In April, 1979, the City contracted with Booker Associates, Inc., (Booker) for professional and technical services to review Route 755's preliminary design as prepared by MSHD in terms of specific engineering design aspects and mitigation of various adverse environmental impacts.

ROUTE 755, ST. LOUIS CITY
North South Distributor Freeway

Plate III

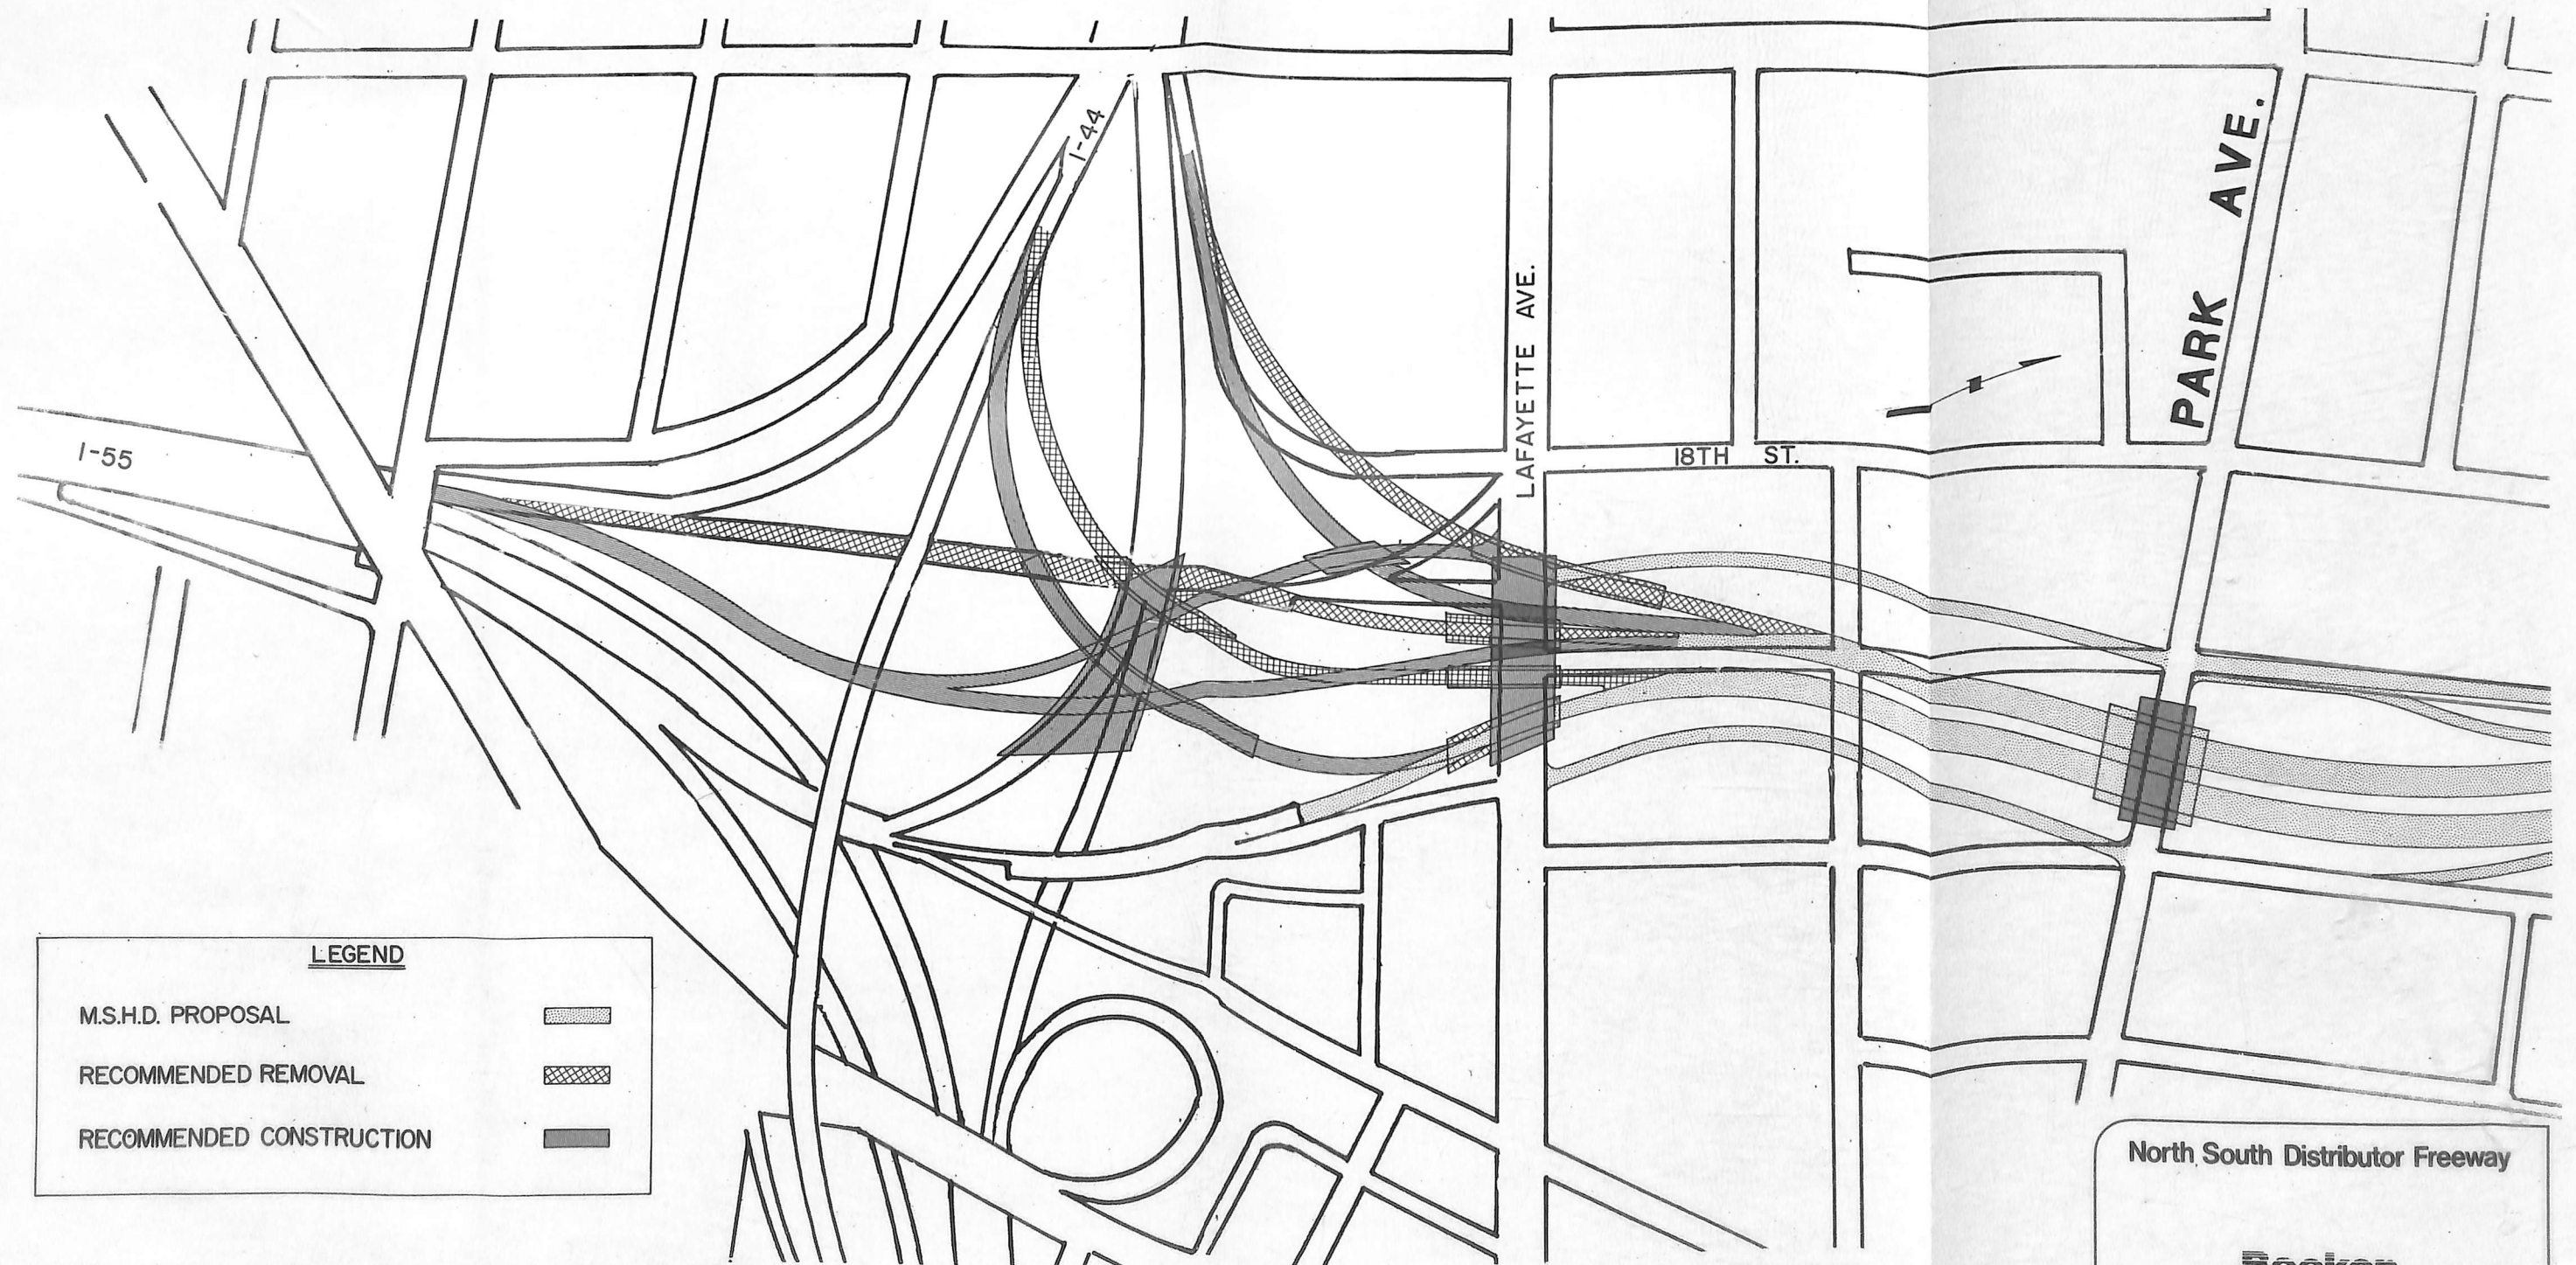
Consequently, the following changes were analyzed and are recommended. First, retain the above change eliminating the Park Avenue access and egress points and relocating them to Lafayette Avenue. This recommendation reduces neighborhood impacts on Park Avenue in general and

Clinton School in particular and routes traffic to Lafayette Avenue which has greater capacity to handle the proposed traffic volume. Second, move the northbound off- southbound on-ramps to the north side of Chouteau Avenue. The off-ramp would intersect with 18th Street south of Gratiot Street and the southbound on-ramp would intersect Chouteau Avenue at Mississippi Avenue. This recommendation would provide the Chouteau Avenue commercial-industrial area with direct access to Route 755 eliminating the need for traffic generated from this area to use neighborhood streets. Additionally, this change eliminates the need for relocated Dolman Street. Therefore, Dolman Street and its right-of-way infringing on the Lafayette Square Historic District can be eliminated entirely, reducing adverse impacts on the neighborhood as shown on Plate III.

Figure 1

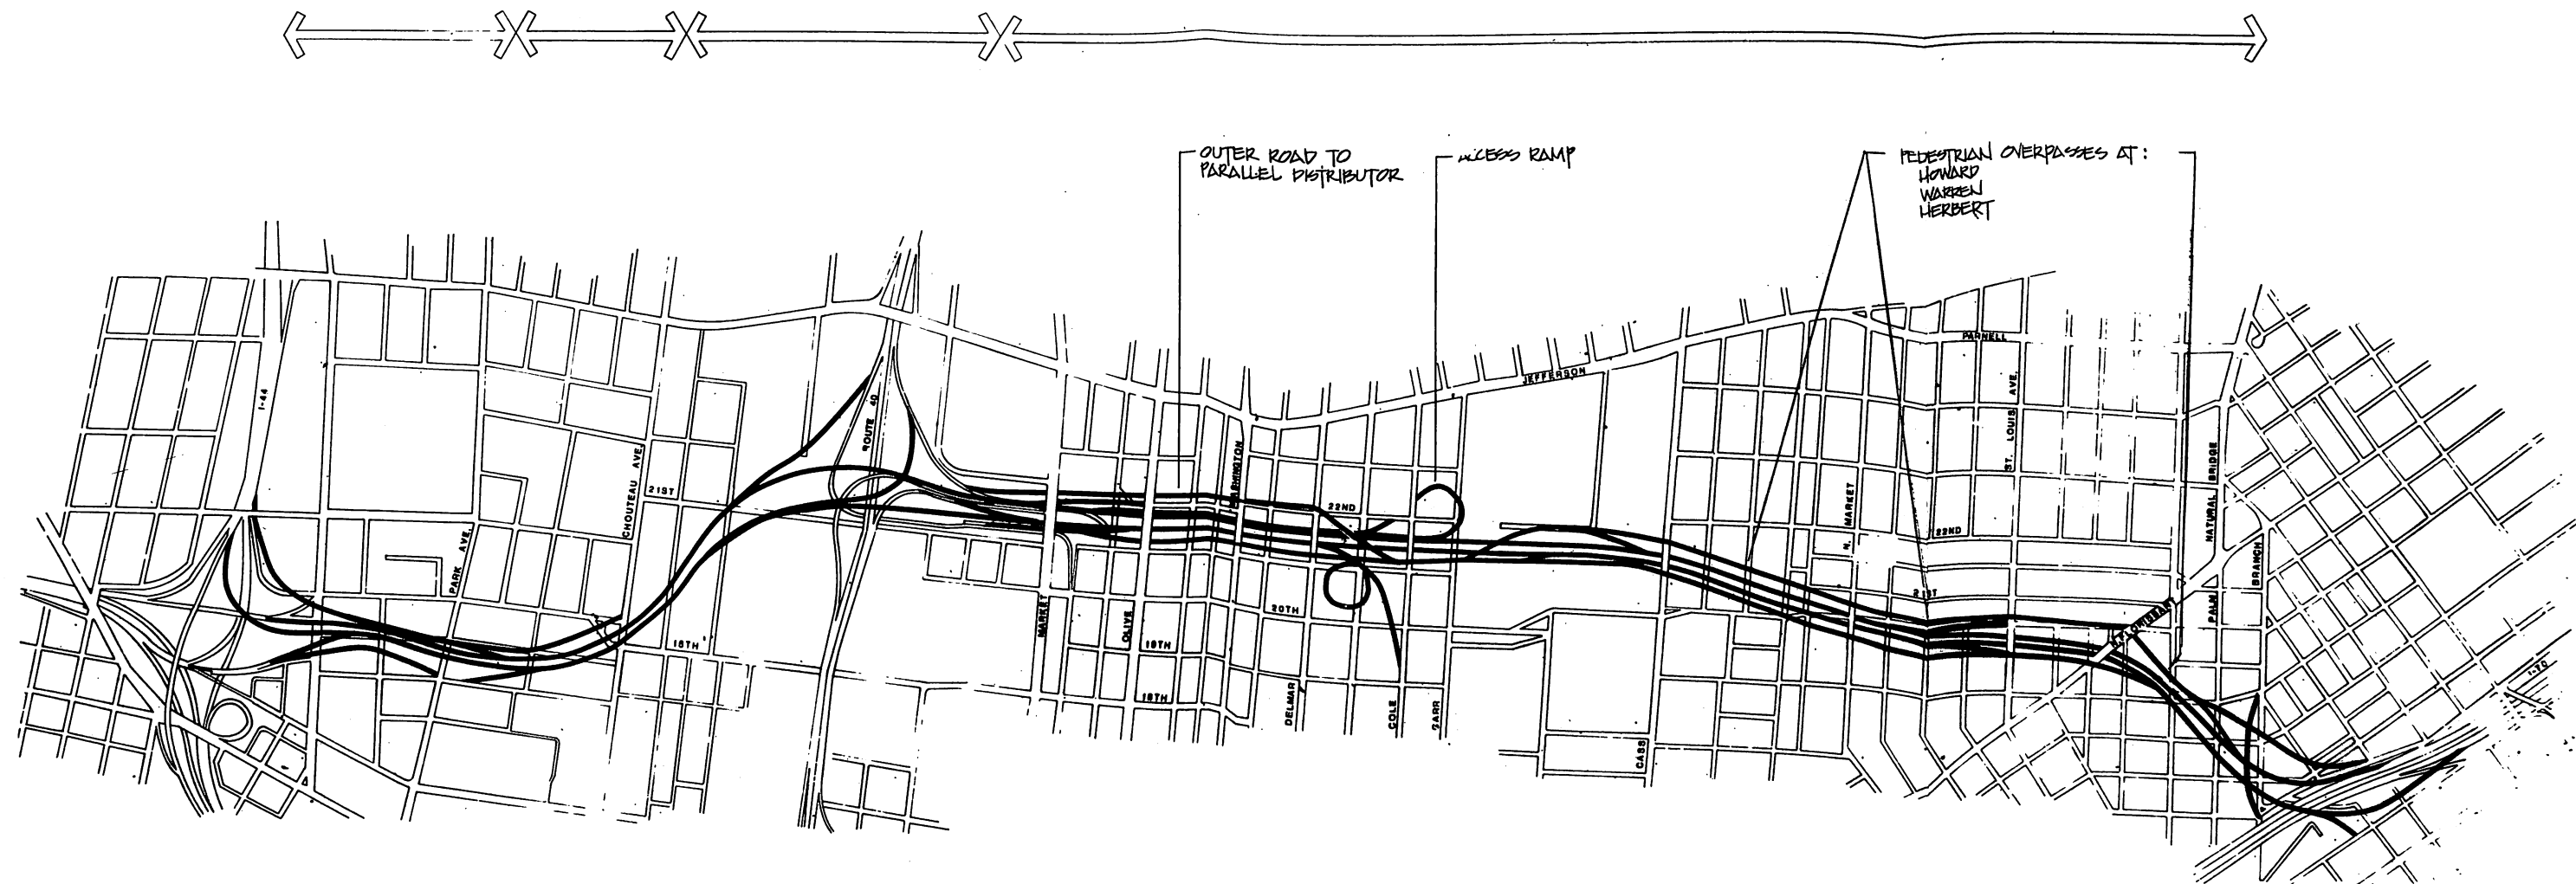
Although the Cole Street interchange, as proposed by MSHD provides for all traffic movements between Cole and Route 755, it is a non-standard interchange with movements that may initially confuse motor vehicle operators (see Figure 1).

The review of possible redesign of this interchange included the possible elimination of the northbound Route 755 off-ramp to Cole Street in the southeast quadrant of the interchange. This loop ramp splits traffic two ways: (1) eastbound on Cole Street, and (2) northbound on the outer roadway and westbound on Cole Street. It was found that no change could be made without either eliminating one of the critical traffic movements or providing an unsafe or below standard situation for particular traffic movements. Specifically, in order to eliminate the loop in the southeast quadrant and simply have an eastbound Cole Street off-ramp, a new loop would be required in the northeast quadrant. However, this alternative would entail intrusion into DeSoto Park and further loss of park land, a solution which was rejected as unacceptable. Therefore, no changes in the design of the interchange as proposed by the Missouri State Highway Department are recommended.

The southern section profile of Route 755, as proposed by MSHD, begins as an elevated section at the interchange of I-55 and I-44 (see Figure 1). This elevated portion continues northward over Lafayette and Park Avenues, changing to a depressed section at Hickory Street and passing under Chouteau Avenue, then rises to an elevated section over the railroad yards and Route 40. In the vicinity of Park Avenue, the facility passes close to City Hospital, Malcolm Bliss Hospital, and Clinton School.

Figure 2

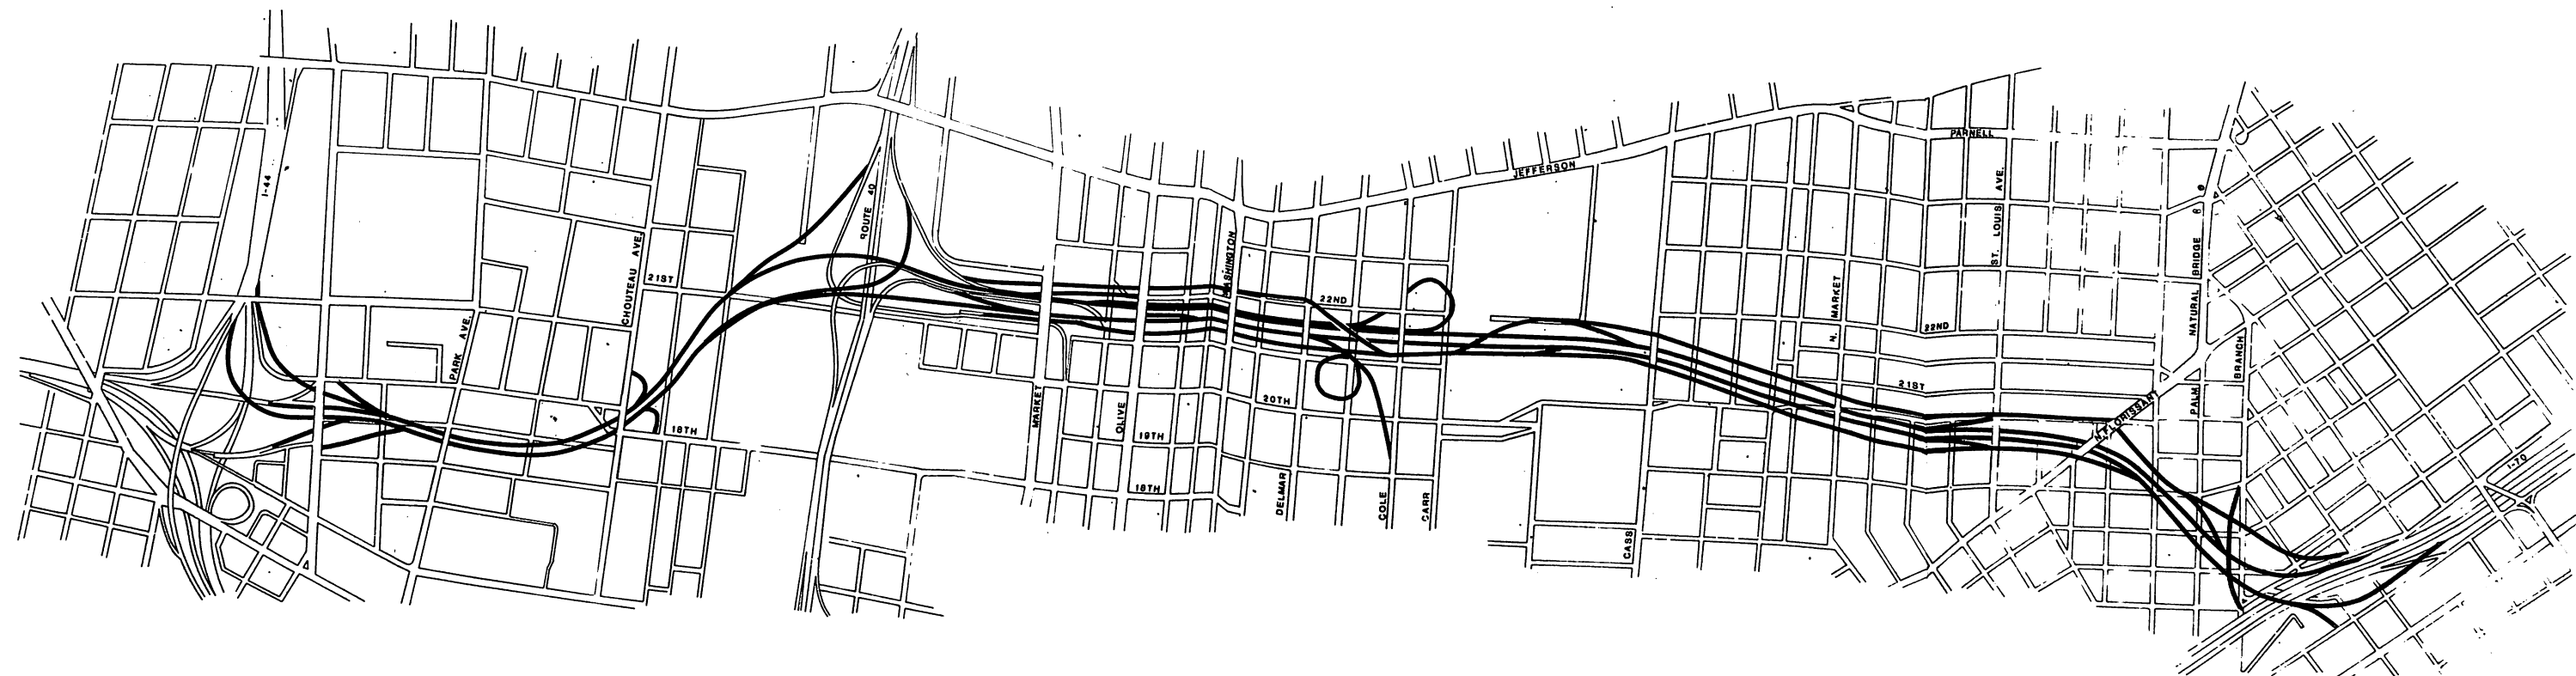
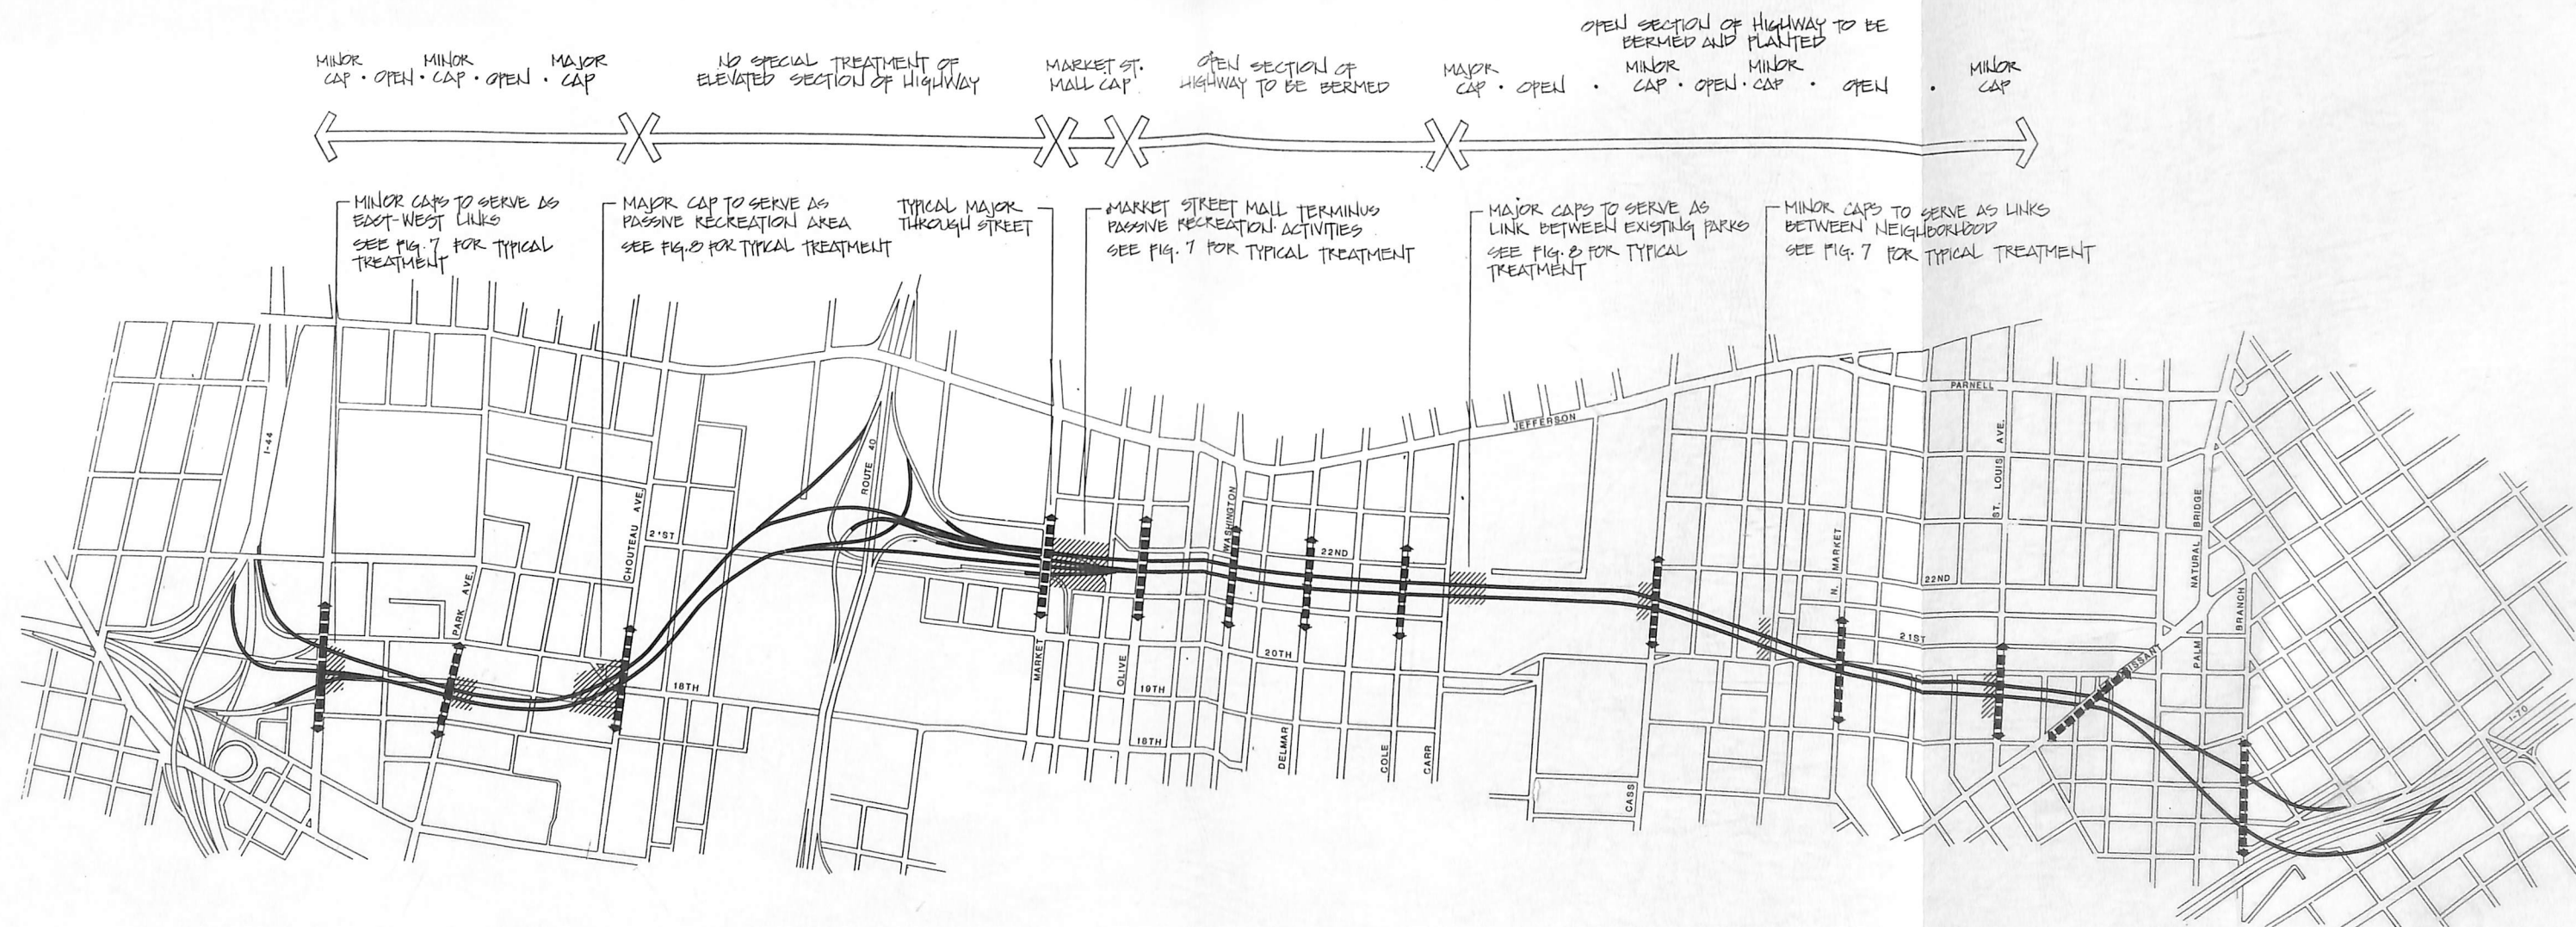
A preliminary analysis was made to determine the feasibility of revising that portion of the proposed facility from an elevated to a depressed section, as shown in Figures 2 and 3. This analysis indicated that the modifications were capable of being accomplished, although at a cost greatly increased compared to the proposed design. The three major considerations in providing a depressed section in this portion of the facility are the maintenance of existing traffic, earthwork, and construction costs; each of which are addressed in specific detail below.
